S4.55 MODIFICATION - LIST OF CHANGES

DWG NO.	ARCHITECTURAL DRAWING NAME	ISSUE	REVISION	DATE ISSUED
GENERAL				
DA.1	TITLE PAGE & ROOF/SITE PLAN	MOD	L	11.08.2025
DA.2	EXISTING LOWER GROUND FLOOR DEMOLITION PLAN			
DA.3	EXISTING GROUND FLOOR DEMOLITION PLAN			
DA.4	EXISTING FIRST FLOOR DEMOLITION PLAN			
DA.5	EXISTING ROOF TERRACE DEMOLITION PLAN			
DA.6	PROPOSED LOWER GROUND FLOOR PLAN			
DA.7	PROPOSED GROUND FLOOR PLAN			
DA.8	PROPOSED FIRST FLOOR PLAN			
DA.9	PROPOSED ROOF TERRACE PLAN [AS IS]			
DA.10	SECTION X-X & Y-Y			
DA.11	NORTH & WEST ELEVATIONS			
DA.12	SOUTH & EAST ELEVATIONS			
~~DA.13~~	~~NEW VEHICLE CROSSING PLAN & SECTION~~			
A.100	AREA CALCULATION PLANS			
LA.001	LANDSCAPE PLANS

DRAWING STATUS:
MODIFICATION APPLICATION

HOUSE DELANEY
Alterations & Additions to Existing House
BCA Class 1a
39 Heathcliff Crescent, Balgowlah Heights
Lot 16 Sec 25 D.P. #758044
SITE AREA 617.4m²

Swimming Pool
Site LocationPlan
SCALE 1:100/A2

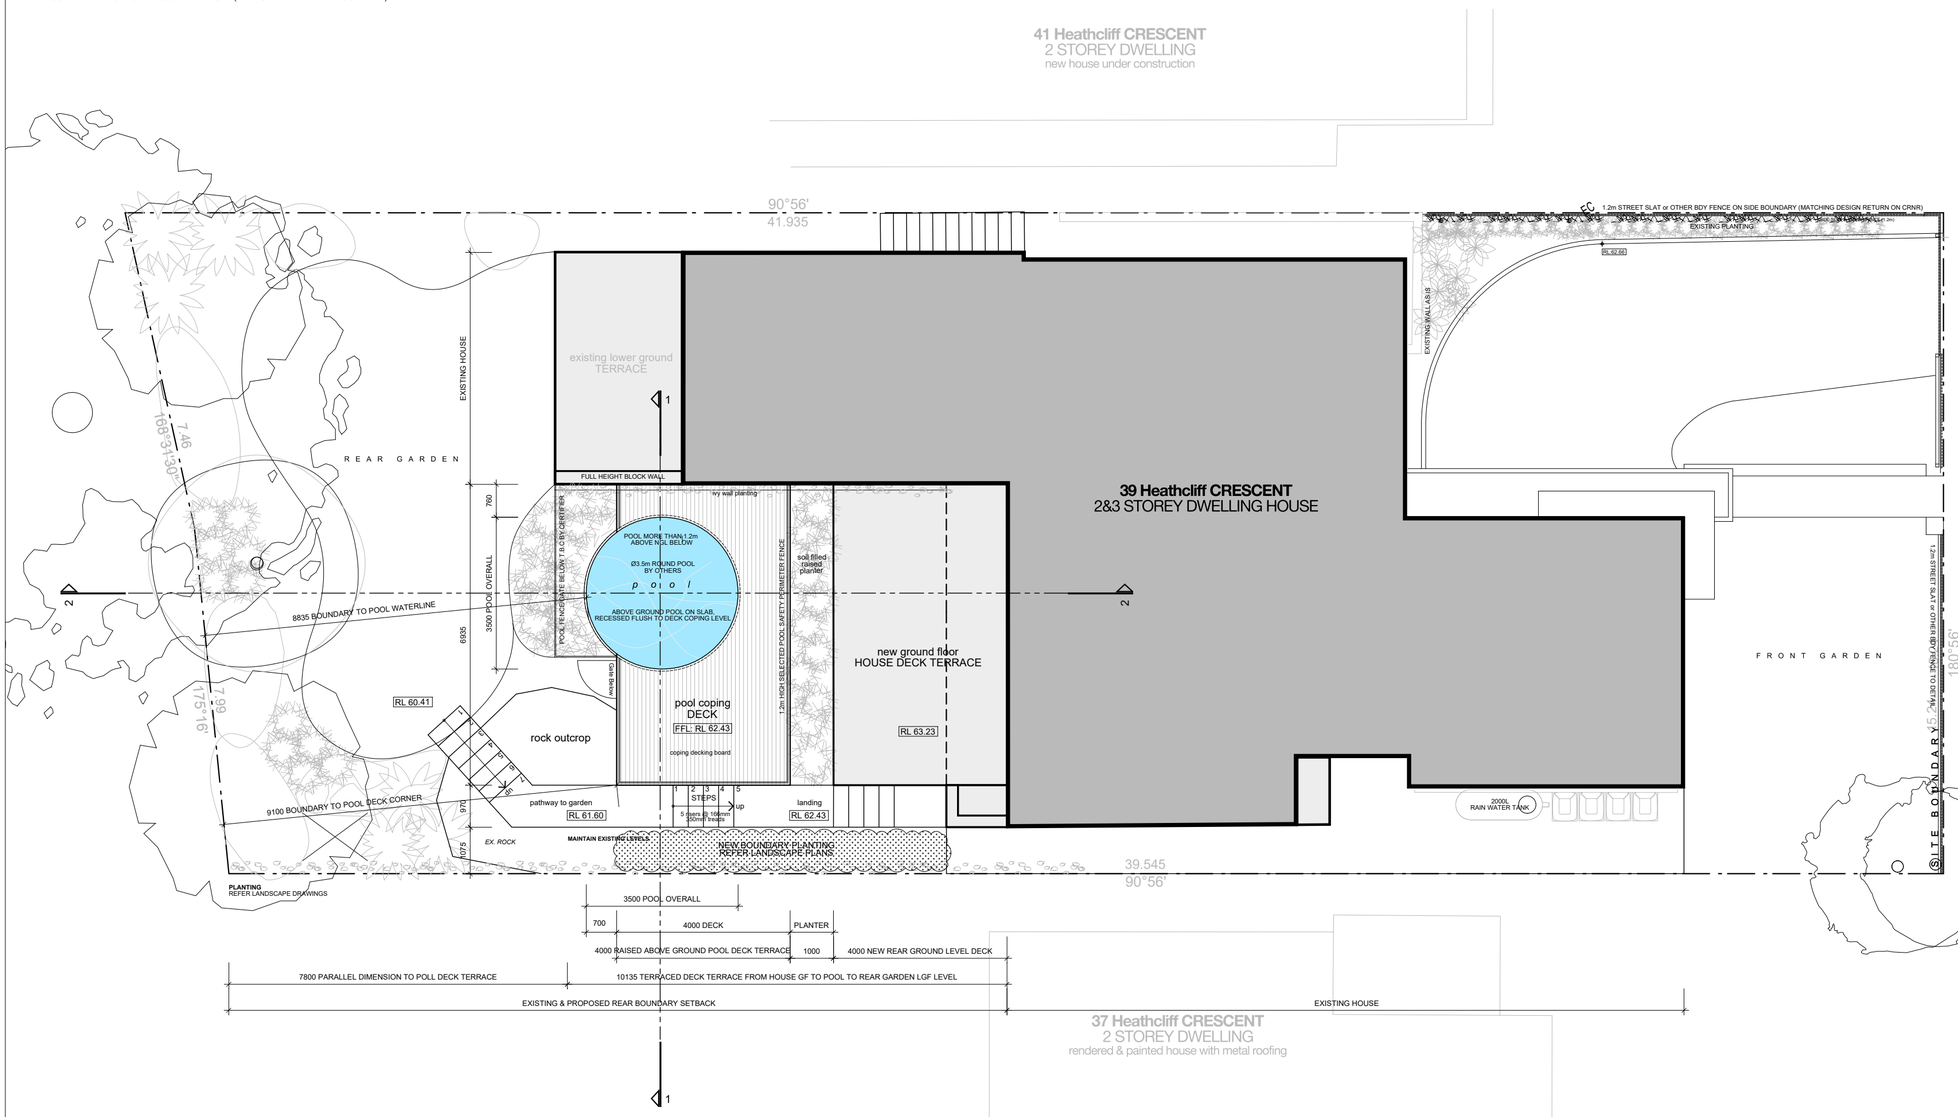
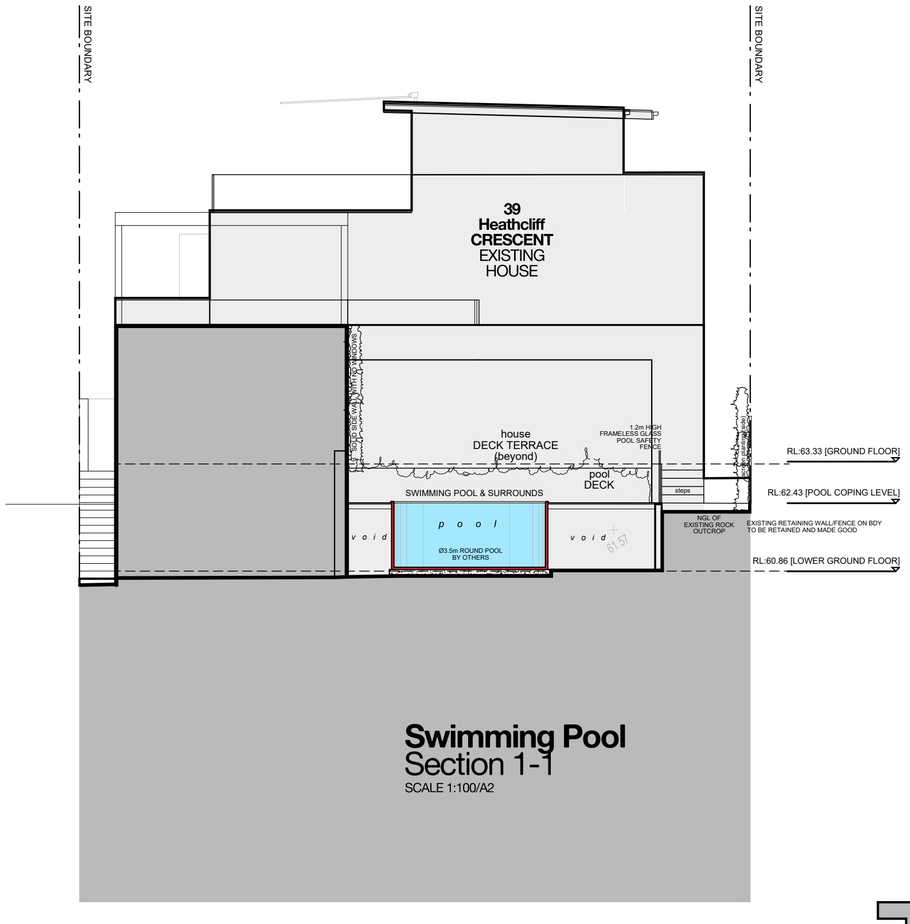
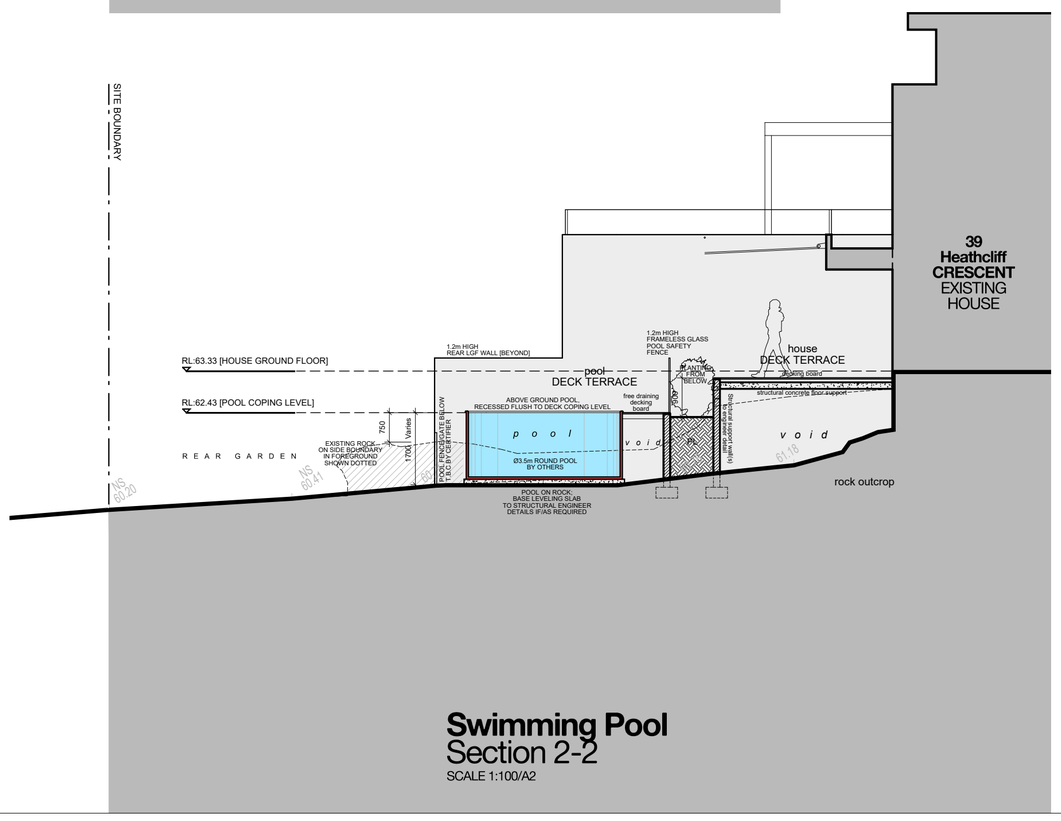
THE ARCHITECT TO REVIEW THE POOL DETAIL DRAWINGS BY OTHERS BEFORE CONSTRUCTION. IF NOT A PRECAST POOL THEN IN-SITU POOL BY OTHERS.
